January 29, 2024

Application for Bulk Variances (**PBA No. 23-11**)
Pamela Rew
62 Strickland Street Place; Block 69, Lot 4
Borough of Bay Head, Ocean County, New Jersey
Colliers Engineering & Design Project No. BAP-0262

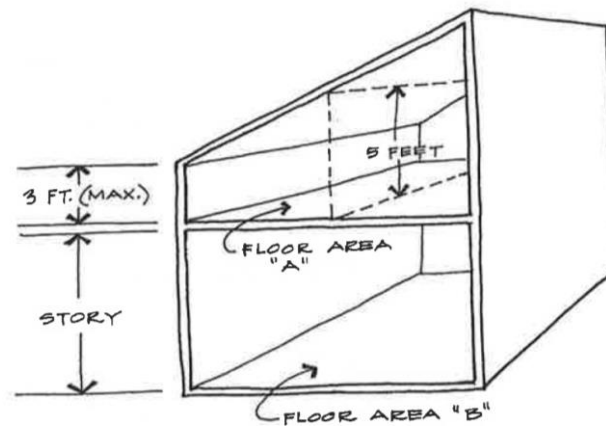
- d. Pursuant to the definition in Section 147-2, a "half-story" is a space under a sloping roof in which the space the possible floor area with headroom of five feet or less (Area "A" on sketch below) occupies at least 40% of the total floor area of the story directly beneath (Area "B" on sketch below).

The existing upper story exceeds the allowable floor area per the "half-story" definition and is therefore non-conforming. The proposed dormer will add 28 square feet of floor area with headroom greater than 5 feet to existing upper story floor area, resulting in a further exceedance of the allowable floor area. Based on the information provided, the upper floor area will be 471 square feet, or approximately 64.3% of the total floor area of the story directly beneath (734 square feet).

In this case, Floor Area "A" occupies only 35.7% of the total floor area of the story directly beneath it and the associated relief is required.

IF FLOOR AREA "A" IS AT LEAST
40% OF FLOOR AREA "B" -
THEN "A" IS A HALF STORY.
